RE: AMENDED REQUEST 200 MW BLAZING STAR WIND FARM 2  
WIND ENERGY PROJECT SITE PERMIT  
DOCKET NO. IP-6985/WS-17-700

The permit amendment is requested to address (1) a new, expanded project boundary; and, (2) an updated turbine layout that incorporates Vestas V-110 and V-120 turbine generator models.

## **Attachment A – Project Boundary Comparison**

# **Attachment C – 2017 and 2019 Layout Comparison**

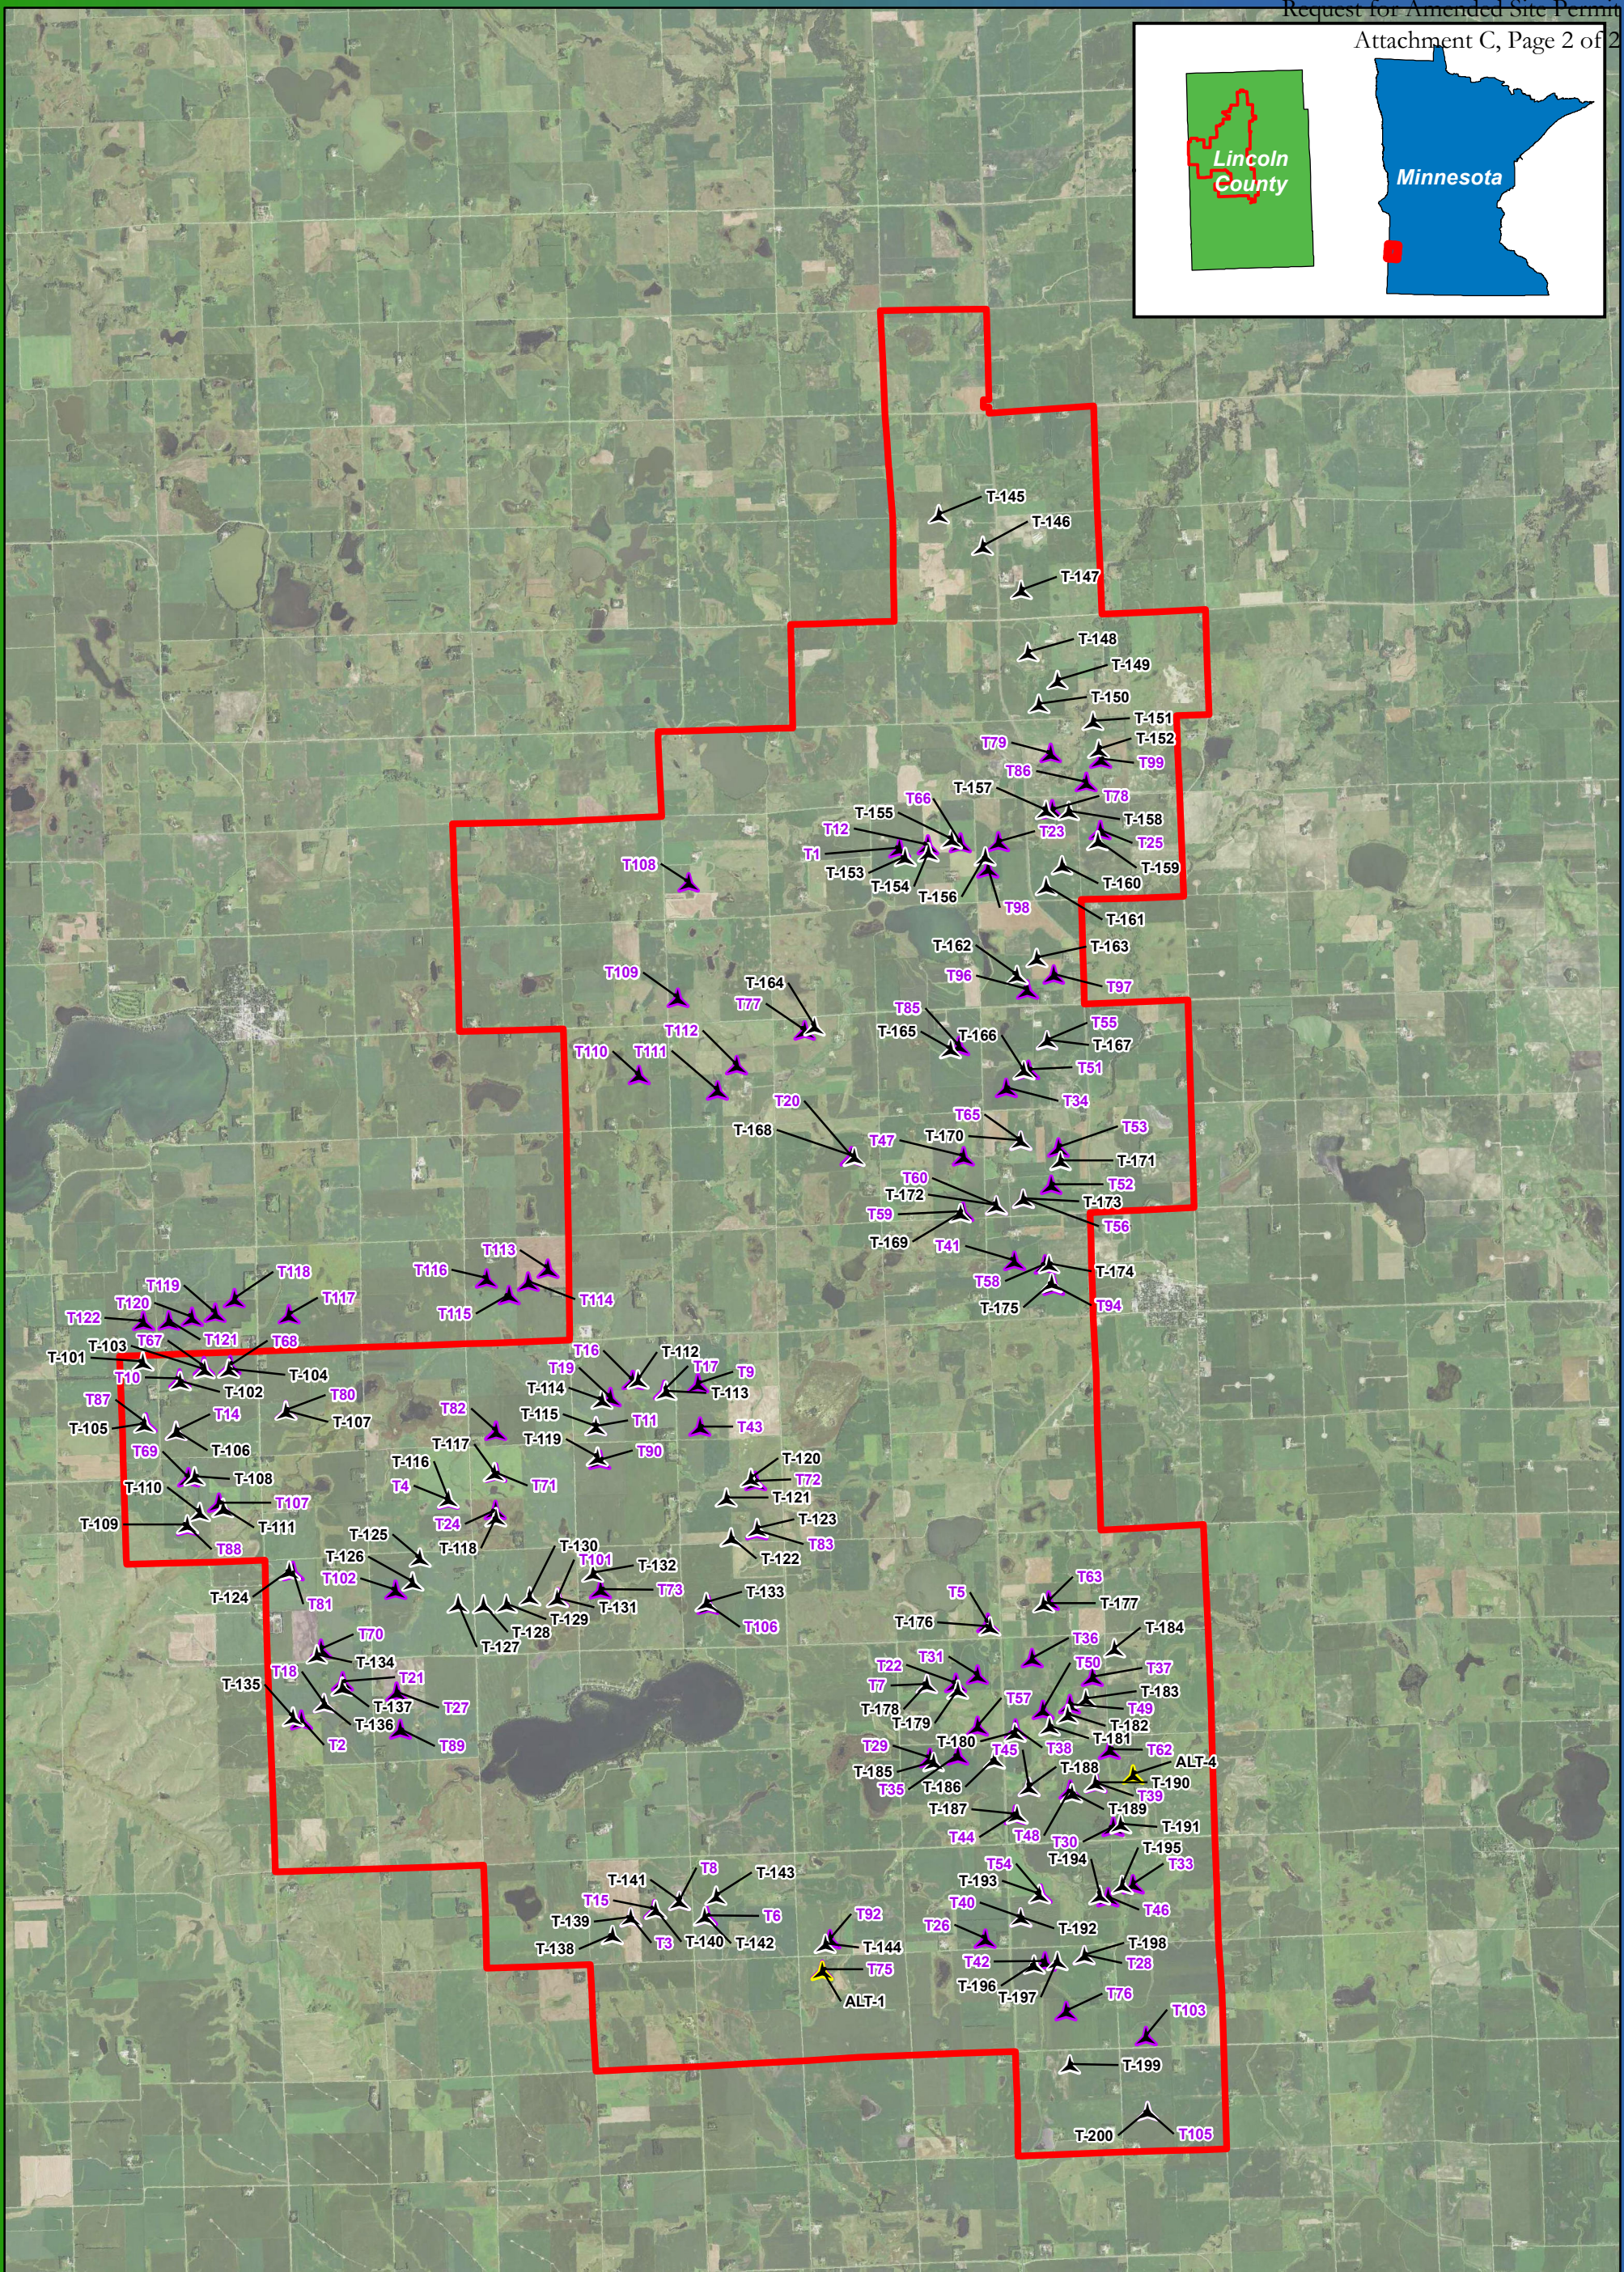
We provide as Attachment C, a figure illustrating the difference between the previously permitted V-110 turbine locations and numbering and the current Vestas V-110/V-120

layout. We additionally provide as Attachment H, a table summarizing the change in turbine locations and numbering. Signage will be present at each turbine location indicating the turbine number and facility ownership. The Company has renumbered the turbine layout from the permitted layouts in order to maintain consistency in turbine numbering schemes between our wind farms.

## **Attachment D – 2019 Project Setbacks**

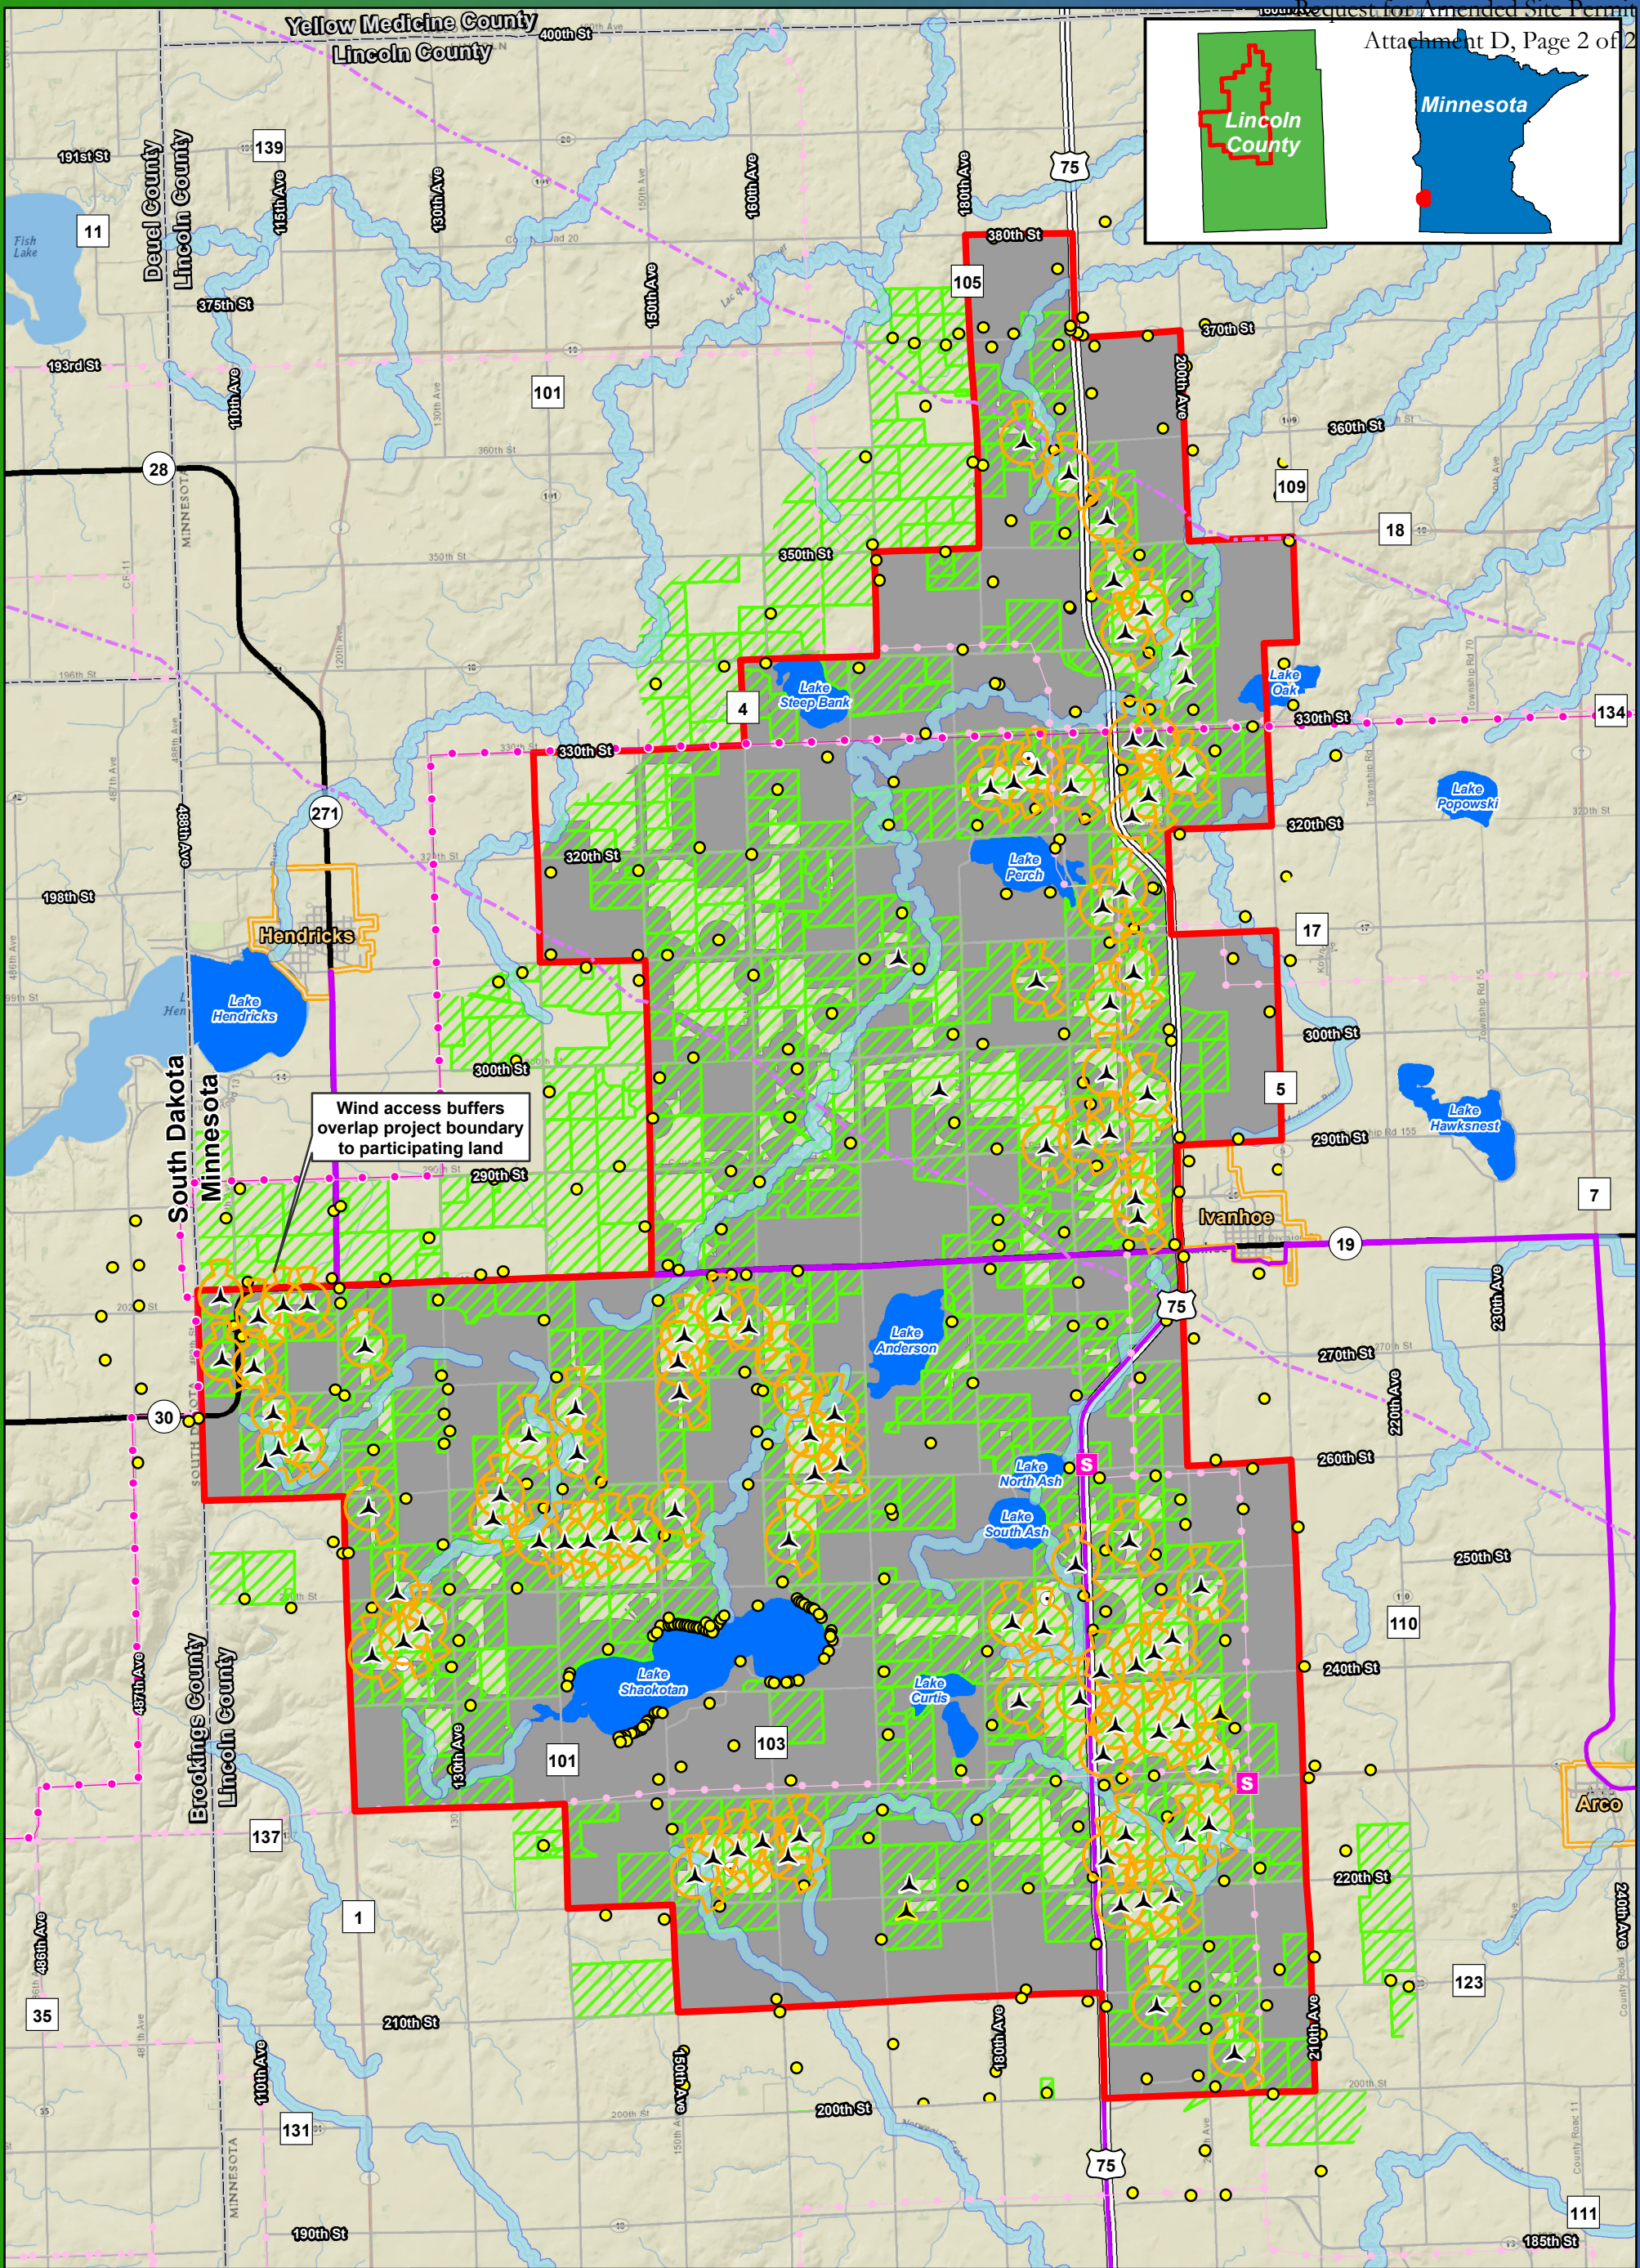
The Company confirms the updated facility layout complies with this requirement. The Figure in Attachment D illustrates the required wind access buffer. The project boundary has changed to incorporate additional easements. A project boundary comparison is provided in Attachment A.

We confirm that the updated facility layout complies with this requirement. The Figure in Attachment D illustrates the setbacks from residences and other features that were applied to the facility layout. The closest turbine to a residence is Turbine 147, which is 1,070 feet from the nearest residence. The nearest non-participating residence is located 1,677 feet from Turbine 104, the nearest turbine. An updated noise assessment for the current layout
